# SERVICE BULLETIN

## Rudder Centering Fork - Control Stop Replacement

### SB-ASTM-CTLS-03

Fig. 1

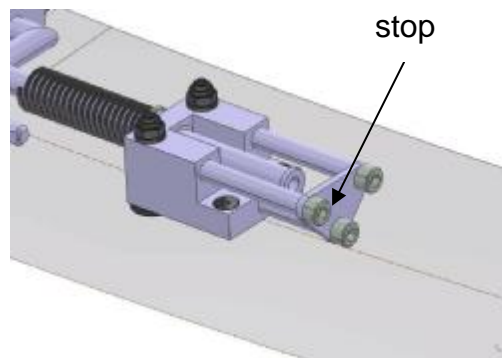
This is the rudder stop system that was installed to the CTLS affected by this SB ex factory. In this system the stop is provided to the rear end of the rudder centering fork, installed to the tunnel, below the instrument board. See following Fig. 1, 2 for illustration.

This system is the system affected by this SB.

Fig. 3

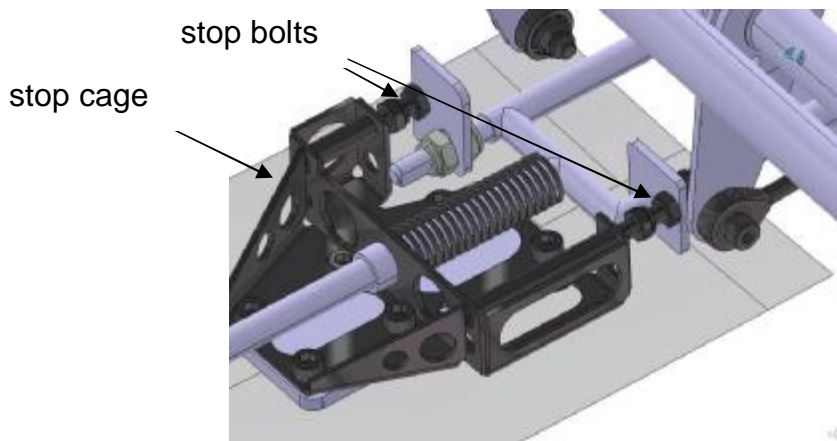
The new fork stop system provides a stop not to the rear end of the rudder centering fork, but to the thrust plates where the rudder centering fork contacts the bolt heads from the rudder pedal levers. The variant is clearly recognizable by the steel welded cage that provides the stops by means of adjustable bolts. See following Fig. 3 for illustration.

This stop device represents the valid type design and is used in serial production at the time of issuing of this SB. Only on aircrafts where the Rudder Stop Plates as by 3.1.3 cannot be used, this new fork stop system must be installed following this SB.

Fig. 4

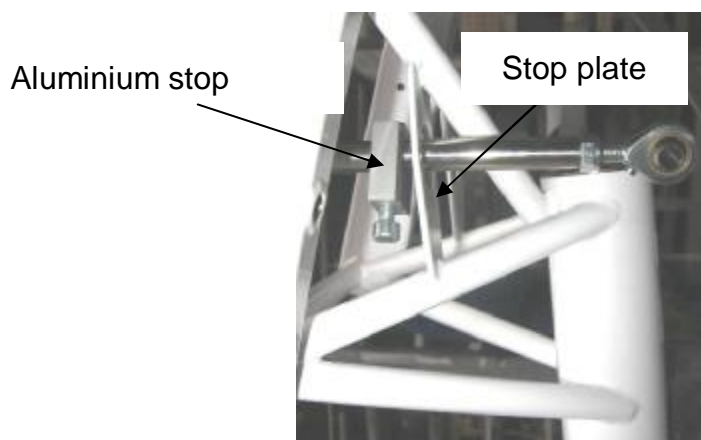
The rudder stop plates provide rudder stop not at the rudder centering fork. Aluminium stops, positioned to the control rods that connect the pedals with the nose gear steering, come to a stop against two stop plates welded to the big engine mount, in front of the firewall. See following Fig. 4 for illustration (only partially installed situation).

This stop device represents the valid type design previous to the introduction of the old fork stop system. It has been replaced in production due to the more complex adjustment process, coupling with the rudder control rope pretension. On aircrafts where the welded stop plates are still available, this previous stop system shall be used again following SB [2], as it is easier and faster to be installed. However, aircraft S/N affected by this SB do not have the welded stop plates installed any more. Therefore this variant cannot be used any more for these aircraft.

Fig. 10

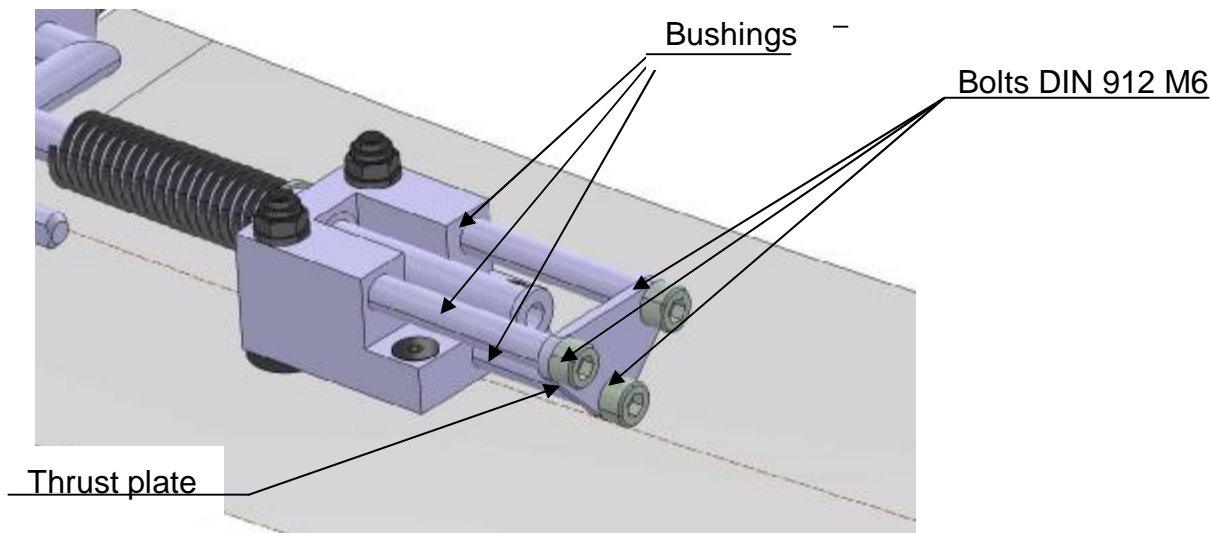
The old fork stop system, that guides the rear end of the rudder centering fork, must be uninstalled when the rudder stop plates are installed. To do this, remove the three bushings, bolts and thrust plate shown in Fig 10 from the fork mount block. Unscrew three (3) DIN 912 M6 bolts (Fig. 10). Discard these parts.

Fig. 11

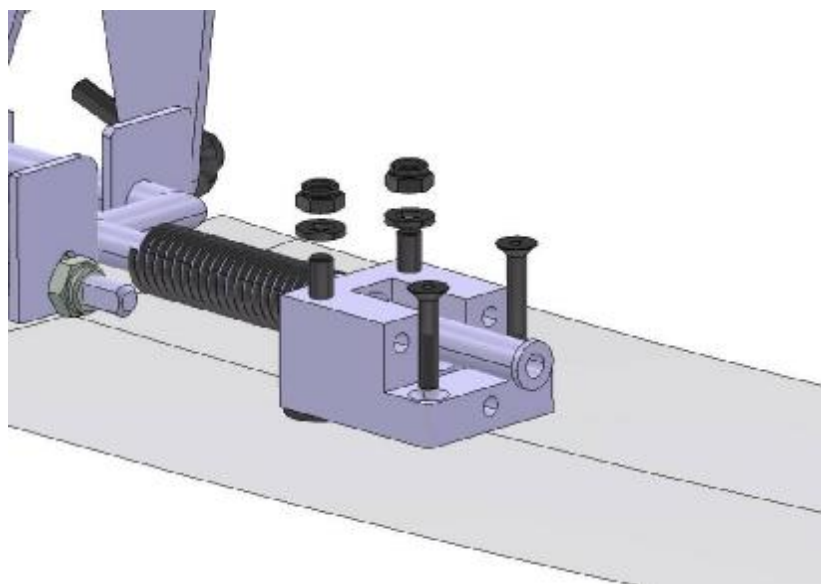
Remove the rear aluminum fork mount block from the lower fuselage skin by unscrewing the 4 bolts as shown in Fig. 11.

**Warning:** The spring installed to the rudder centering fork provides a pretension to the system and will push the aluminium block to the rear, once all bolts are removed.

Fig. 12

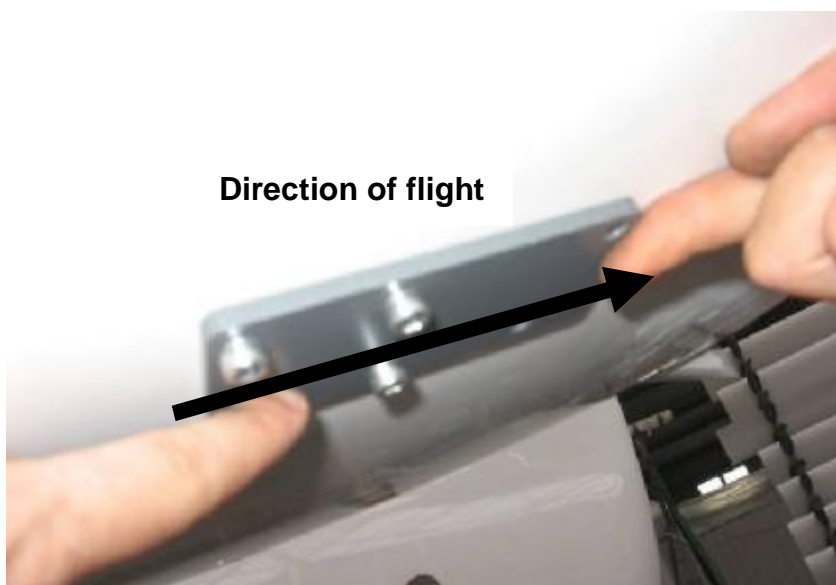
Temporarily install PVC plate KF27200223 from the outside to the bottom fuselage using four (4) bolts (Fig. 12).

**Warning:** Installation must be exactly in the same position as the installation will be later on in the aircraft, so not turned upside down. When looking in direction of flight, the most forward hole on the left side must be rear of the most forward hole on the right side. Pay special attention, when drilling the holes you look from below In case of doubt use the new fork stop cage to cross check. See Fig 6.

Fig. 13

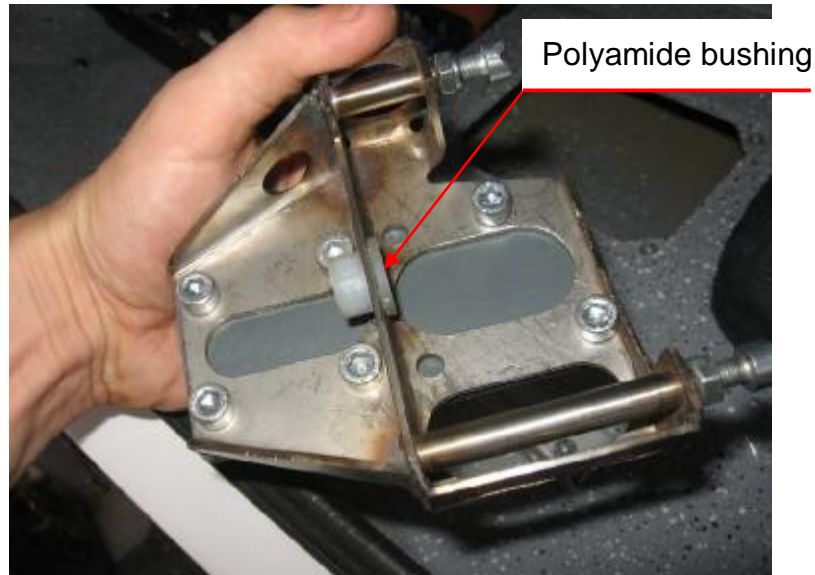
Remove polyamide bushing from the aluminum support that was uninstalled in step 3.3.3. Install this polyamide bushing to the guide hole of the new rudder stop device (Fig. 13).

Take the new fork stop system cage and place the PVC plate on the lower side and insert the 6 attachment bolts (Fig 13).

Fig. 16

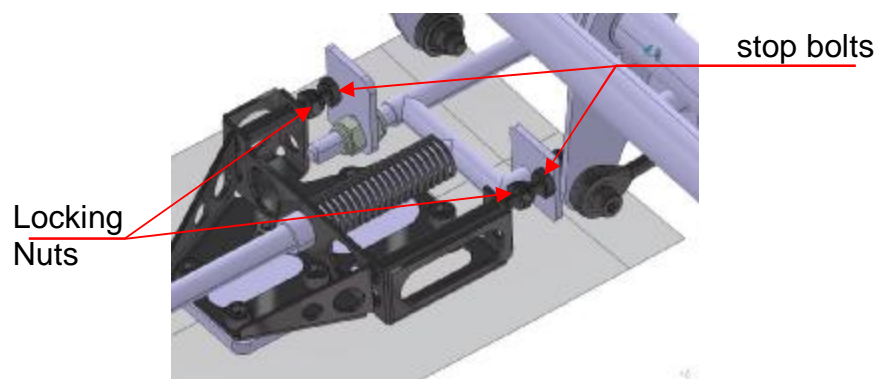
Adjustment of the rudder stops is achieved by changing the length of the stop bolts, inserted to the new fork stop system cage (Fig. 16). When deflected, the fork plates are pushed against these stop bolts. Changing both of the bolts allows increasing or decreasing the maximum rudder deflection.

**Warning:** The stops on both sides of the new system must be installed so that the stop at the side where the pedal is deflected touches the centering fork first or at the same time as the other side does. The opposite stop from the deflected pedal cannot touch first.

After finishing of the adjustment tighten the locking nuts (Fig 16) on the stop bolts.

Fig. 17

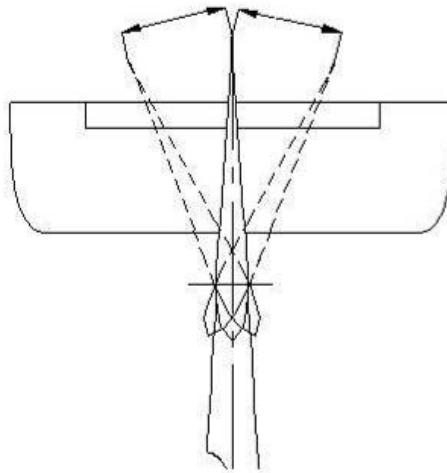
Maximum rudder deflection is measured at the lower trailing edge of the rudder as shown in Fig 17.

206-228mm (8-9 in)
